Access Compliance Report

Public Rights-of-Way

Intersection ID: 8987	Main Street: GRIER_AV	Cross Street: WELCH_PL	Location: NW
ADA ID: 36D7D81804E4	Ramp Type: Perp	Initial Pass/Fail: Fail	Overall Compliance: No
		Severity Score: 10

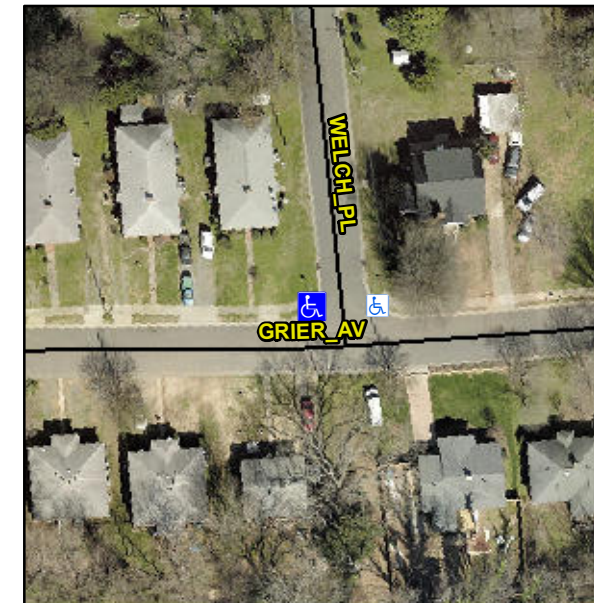
Not Found, R304.5.1, R304.5.3

Compliance	Description	Data	Compliance	Description	Data
N/A	Ramp Length (in)	49.0	Yes	Ramp Slope (%)	6.5
No	Ramp Width (in)	46.0	No	Ramp XSlope (%)	4.7
N/A	Flare Type LT	N/A	N/A	Flare Type RT	N/A
N/A	Flare Slope LT (%)	N/A	N/A	Flare Slope RT (%)	N/A
N/A	Flare Traversable LT?	N/A	N/A	Flare Traversable RT?	N/A
N/A	Landing Length (in)	N/A	N/A	DWS Provided?	N/A
N/A	Landing Width (in)	N/A	N/A	DWS Contrast?	N/A
N/A	Landing Slope (%)	N/A	N/A	DWS Length (in)	N/A
N/A	Landing X Slope (%)	N/A	N/A	DWS Full Width?	N/A
N/A	Landing Curb? (Y/N)	N/A	N/A	DWS Offset (in)	N/A
N/A	Shared Landing?	N/A			
N/A	Gutter Ponding?	N/A	N/A	Gutter Slope (%)	N/A
N/A	Gutter Lip Ht (in)	N/A	N/A	Gutter X Slope (%)	N/A
N/A	Painted X Walk1?	No	N/A	Painted X Walk2?	N/A
	X Walk 1 Direction	To E		X Walk 2 Direction	N/A
N/A	X Walk 1 Width (in)	N/A	N/A	X Walk 2 Width (in)	N/A
	X Walk 1 Slope (%)	3.2		X Walk 2 Slope (%)	N/A
	X Walk 1 X Slope (%)	3.0		X Walk 2 X Slope (%)	N/A

Remove & Replace Entire Ramp.
